BENDIGO-OPHIR GOLD PROJECT

GENERAL CONDITIONS WHICH APPLY TO ALL OF THE RESOURCE CONSENTS WITHIN THE JURISDICTION OF THE OTAGO REGIONAL COUNCIL

Notes: The 'comment' column has been provided for guidance and interpretation purposes only and is not proposed to form part of the consent conditions.

Attachment X – Contents of Ground Control Management Plan for Open Pit Mines

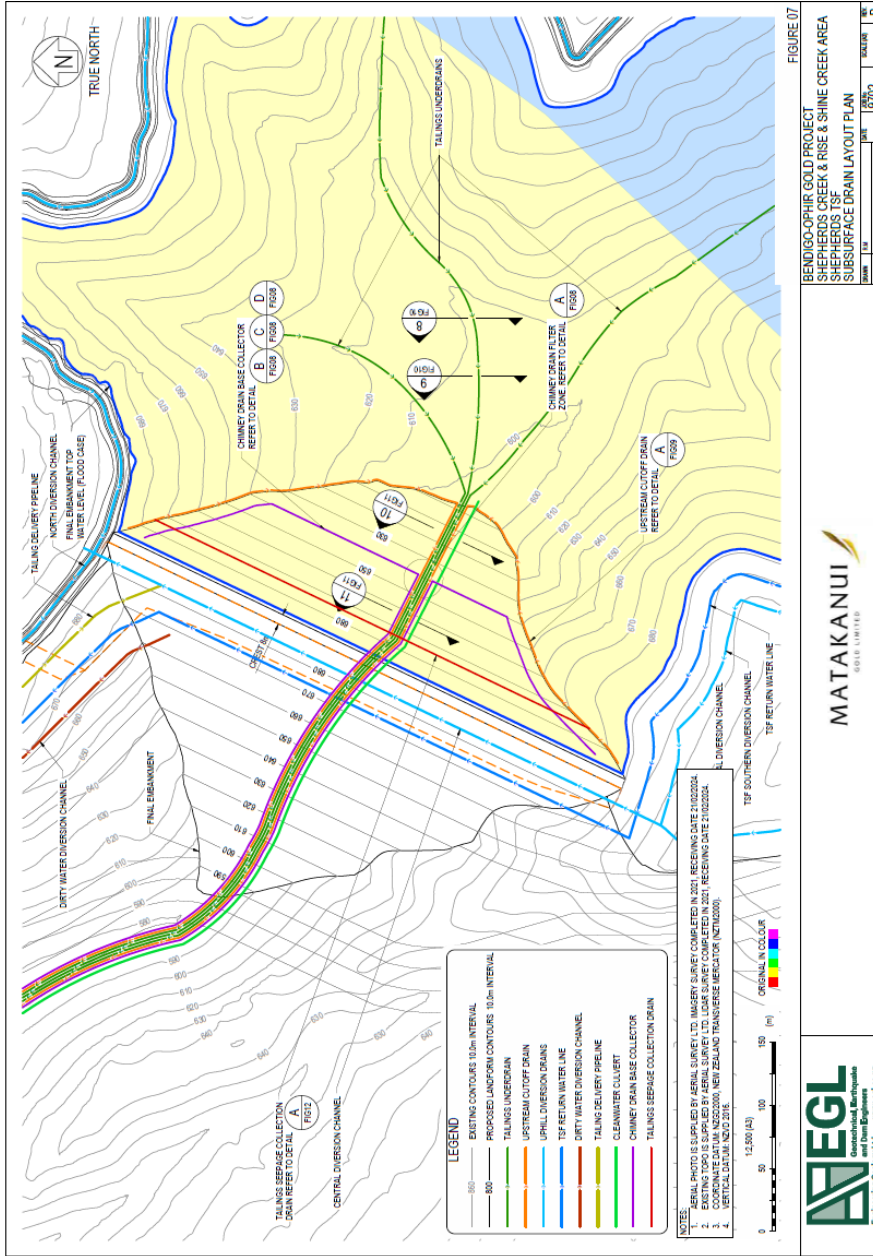
Commented [ORC1]: Applicant to please provide a word version of these contents (taken from Peter O'Bryan Technical Memorandum 24053C, dated 2 February 2026). ORC was provided with a locked PDF hence screen shots of the relevant information have been taken.
